Access Compliance Report

Public Rights-of-Way

(Curb Ramps)

Intersection ID: 10019873	Main Street: ARCHDALE_DR	Cross Street: N/A	Location:	N
ADA ID: 4035442F4AB6	Ramp Type: BlendTrans2	Initial Pass/Fail: Fail	Overall Compliance: No	Severity Score: 42.5

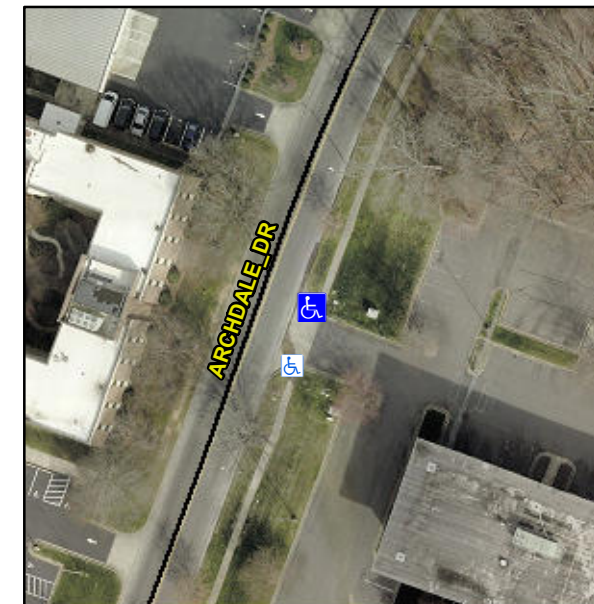
NO LNDG

R304.5.1, R304.5.3

Compliance	Description	Data	Compliance	Description	Data
N/A	Ramp Length (in)	59.0	Yes	BlendTrans Slope (%)	3.1
No	Ramp Width (in)	35.0	No	BlendTrans XSlope (%)	10.2
N/A	Flare Type LT	N/A	N/A	Flare Type RT	N/A
N/A	Flare Slope LT (%)	N/A	N/A	Flare Slope RT (%)	N/A
N/A	Flare Traversable LT?	N/A	N/A	Flare Traversable RT?	N/A
N/A	Landing Length (in)	N/A	N/A	DWS Provided?	N/A
N/A	Landing Width (in)	N/A	N/A	DWS Contrast?	N/A
N/A	Landing Slope (%)	N/A	N/A	DWS Length (in)	N/A
N/A	Landing X Slope (%)	N/A	N/A	DWS Full Width?	N/A
N/A	Landing Curb? (Y/N)	N/A	N/A	DWS Offset (in)	N/A
N/A	Shared Landing?	N/A			
N/A	Gutter Ponding?	N/A	N/A	Gutter Slope (%)	N/A
N/A	Gutter Lip Ht (in)	N/A	N/A	Gutter X Slope (%)	N/A
N/A	Painted X Walk1?	No	N/A	Painted X Walk2?	No
	X Walk 1 Direction	To W		X Walk 2 Direction	To SW
	X Walk 1 Width (in)	N/A		X Walk 2 Width (in)	N/A
	X Walk 1 Slope (%)	3.2		X Walk 2 Slope (%)	9.9
	X Walk 1 X Slope (%)	9.9		X Walk 2 X Slope (%)	4.3

Remove & Replace Curb Ramp With Two New Directional Ramps or Equivalent.
